2014 - 2015 Corvette: Service Bulletin: Creak or Snap Noise Above Windshield from Removable Roof Lift Off Panel While Driving

GM Bulletin No.: #15-NA-016

Date: September 30, 2015

MODELS: 2014 - 2015 Chevrolet Corvette

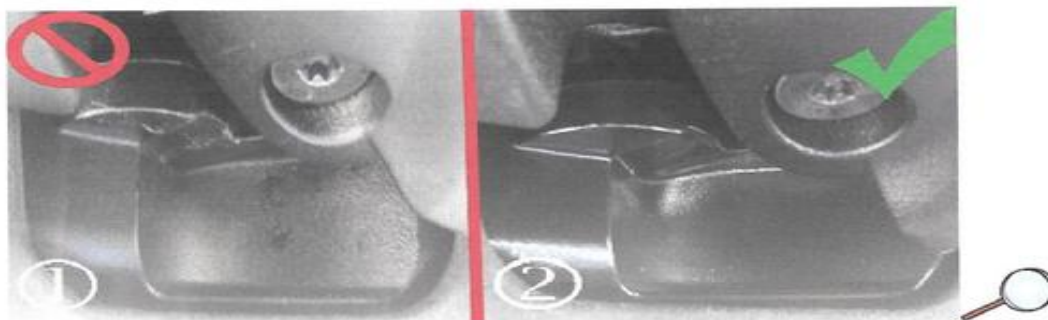
- (1) Example of a bad front locating pin.
- (2) Example of a good front locating pin.

- (1) Example of a bad striker.
 (2) Example of a good striker.

If you encounter a vehicle with the above concern, replace both the front roof lift off panel strikers and both front locating pins. Refer to Roof Lift Off Panel/Window Front Striker Replacement and Removable Top Locating Pin Replacement in SI.
